SHARED USE PATH TYPICAL

PROJECT NAME:	BURLINGTON - COLCHESTER
PROJECT NUMBER:	STP Bike(45)
FILE NAME:	/str5/01f132/sf132typ.dgn
PROJECT LEADER:	C. Keller
DESIGNED BY:	G. Shongraw
PLOT DATE:	15-NOV-2002
DRAWN BY:	G. Shongraw
CHECKED BY:	M.E.M.
SHEET	3 OF 87

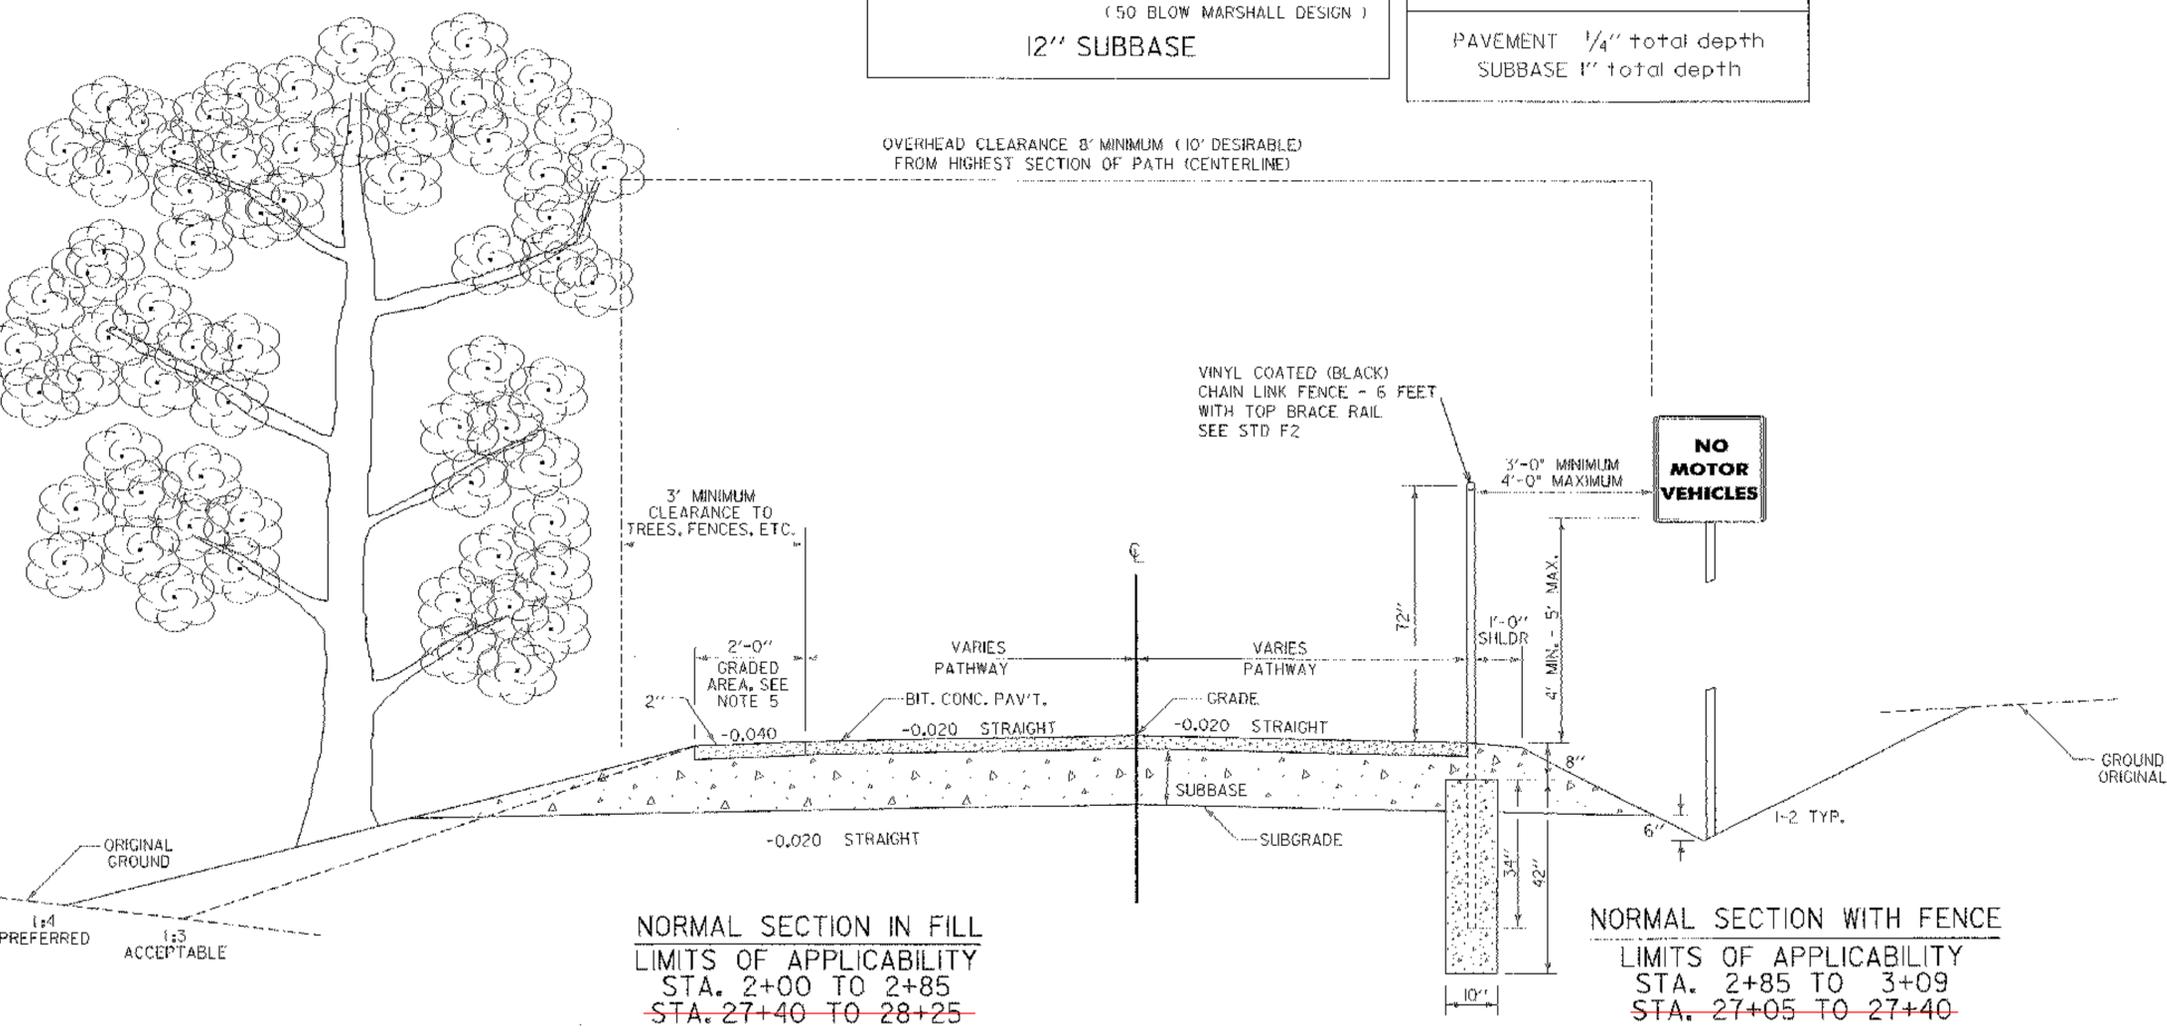
NORMAL SECTION IN FILL
LIMITS OF APPLICABILITY
STA. 2+00 TO 2+85
~~STA. 27+40 TO 28+25~~

NORMAL SECTION WITH FENCE
LIMITS OF APPLICABILITY
STA. 2+85 TO 3+09
~~STA. 27+05 TO 27+40~~

~~CAST IN PLACE CONCRETE SECTION W/ STEEP SIDESLOPES~~
LIMITS OF APPLICABILITY
STA. 8+75 TO 12+04.23

~~NORMAL SECTION WITH CURB~~
LIMITS OF APPLICABILITY
STA. 28+25 TO 28+62
